Certificate of Appropriateness

3133 E. NEWBERRY BL. Lake Park Pavilion in the North Point North HD

4/6/2020 PTS ID 114939 COA: New roof on Lake Park Pavilion

RE: TEAR-OFF AND RE-ROOF APPROX. 13,500 FT. OF ROOF AREA ON THE BUILDING LOCATED AT 3133 E. NEWBERRY BLVD MILWAUKEE, WI 53211-

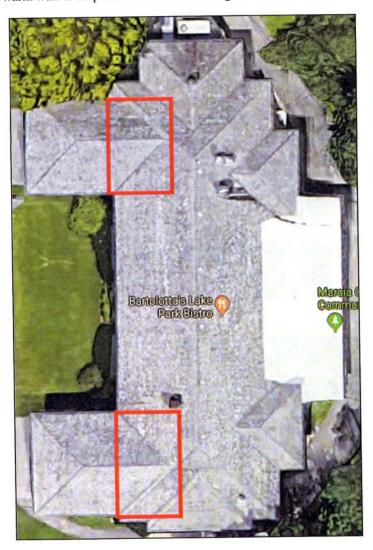
18. We will furnish and install approx. (4) courses of ice and water shield protection to the roof areas above the patio openings. This will assure the ice and water shield will be installed to extend a minimum of 24" beyond the interior of the warm wall to help combat ice dams during the winter months.

Assuring the ice and water shield protection extends a minimum of 24" past the interior warm wall is critical in these areas.

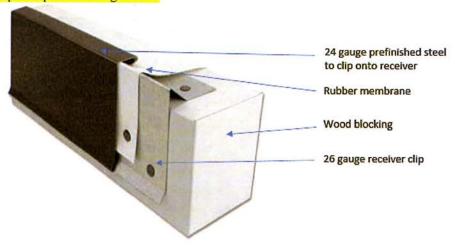
44. The new KEE material will be extended and adhered down into the gutter and secured with a 4" tall aluminum bar, with 4" on center drain slots. This 4" aluminum bar will be utilized to help protect the gutters from sliding ice and snow.

4" termination bars will be installed In the gutter to help prevent sliding Snow and ice from damaging the The gutter as well as help prevent The risk of sliding snow and ice From causing injury below
